APPLICATION NO.	FILING DATE	FIRST NAMED INVENTOR	ATTORNEY DOCKET NO.	CONFIRMATION NO.
10/511,286	12/05/2005	Winfried Habel	3027	1859
7590 Striker Striker & Stenby 103 East Neck Road Huntington, NY 11743				
EXAMINER COLLINS, JASON M				
ART UNIT 2833		PAPER NUMBER		
NOTIFICATION DATE 07/10/2008		DELIVERY MODE ELECTRONIC

Office Action Summary

10/511,286

Figure 3 of Ozaki et al.

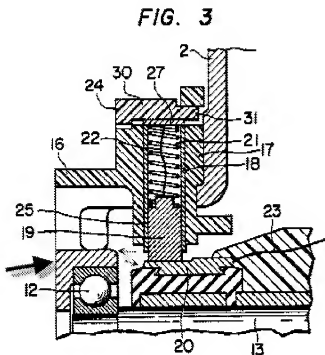
Ozaki et al. show an electrical motor with a holder (Fig 3, element 16), a spring (21), a collector (20), a pivot bearing (12), a means to protect against entry of dirt (the large arrow on the left), and one or more chamfers (small arrows inside) for the carbon brushes (19) to slide over.

Regarding claims 2-4, Ozaki also shows an armature disk (near 20), and a bearing dome (near 12), chamfered for the carbon brushes to slide over when removed for replacement.

Regarding claims 5 and 6, the chamfered surface has a curved course and extends rectilinearly.
